Objection to Planning Application 2024/70/90991/E (Yorkshire Country Properties now called Vivly)

The original planning application 2020/62/93358/E was approved 5th October 2021. The applicant was required to demonstrate how the adjacent land would be developed and submitted this plan described as Master Plan 1914-MP-03D

111 **Proposed Header and Gradient Issue**

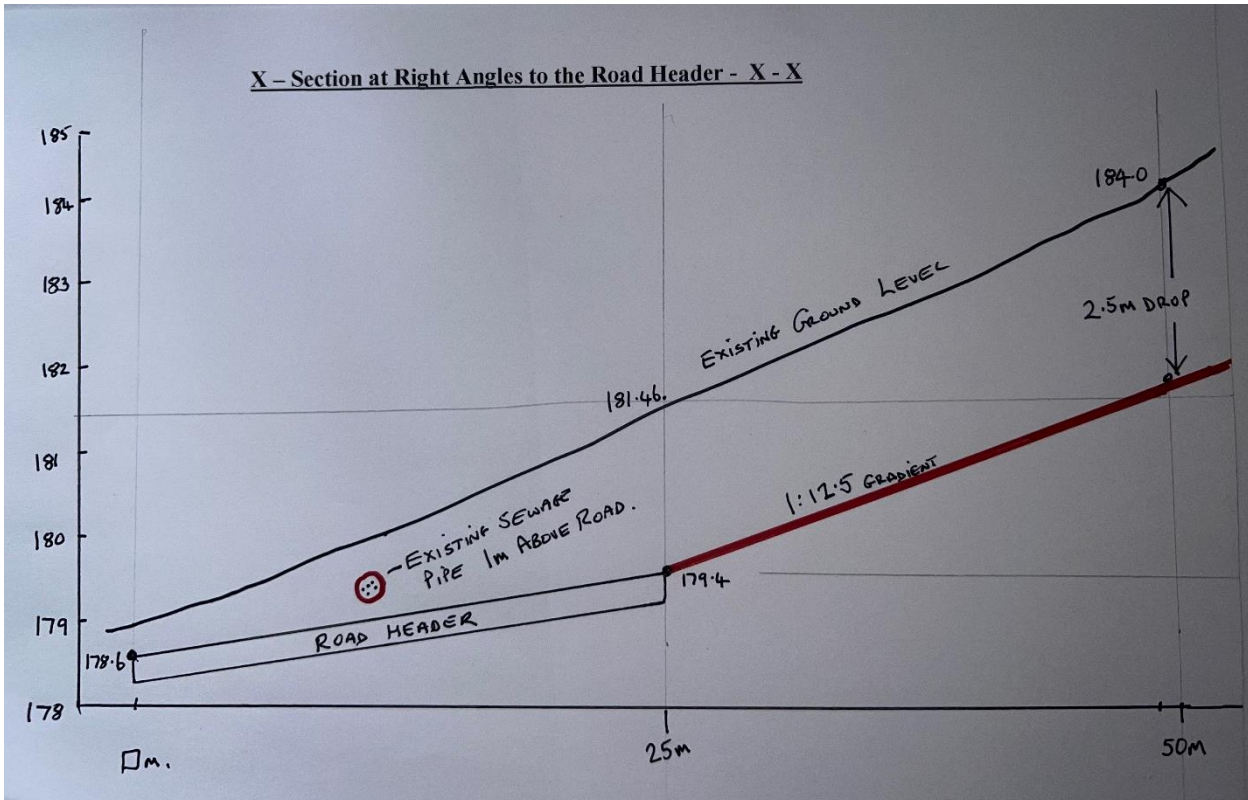
113 This is a cross section of the Road Header seen on the X-X profile above.

117 The header is 25m wide with a slow gradient of 1:31.

118 At the highest point on the header to the east, it is 2m (181.46–179.4) below ground level.

119 Going east toward the 7 plots, the ground level continues to rise further. In the next 25m, the
120 ground is 4m above the header. As seen on the plan in red, a road with a gradient of 1:12.5
121 cannot keep up with the rising ground level.

122 If the proposed plans were approved, gaining access at adoptable standards would require the
123 removal of thousands of tonnes of heavy clay and the construction of large, unsightly retaining
124 walls. This would be a very poor use of land and could result in long road runs to lower the
125 gradients. Perhaps some compromise could be reached?

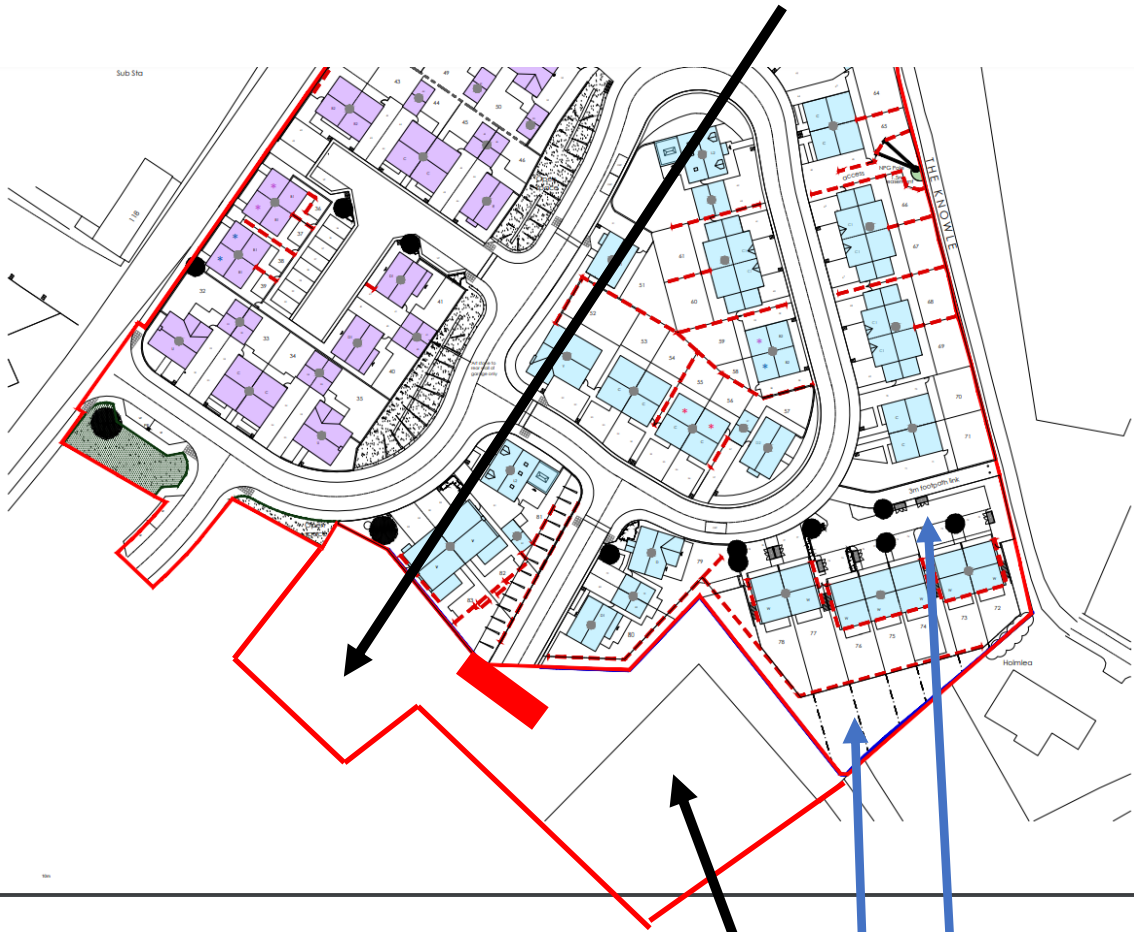
129 The existing proposal would provide good access to the bottom of the adjacent land.

132 As explained above, the top half of the land to the east would
133 face access challenges due to the steep gradient.

134 We also note that these long gardens, as per the Vivly plan, would be
135 underused and represent wasted building space that could provide extra
136 plots elsewhere.

137 Additionally, note how these houses share an awkward drive without adequate parking facilities.
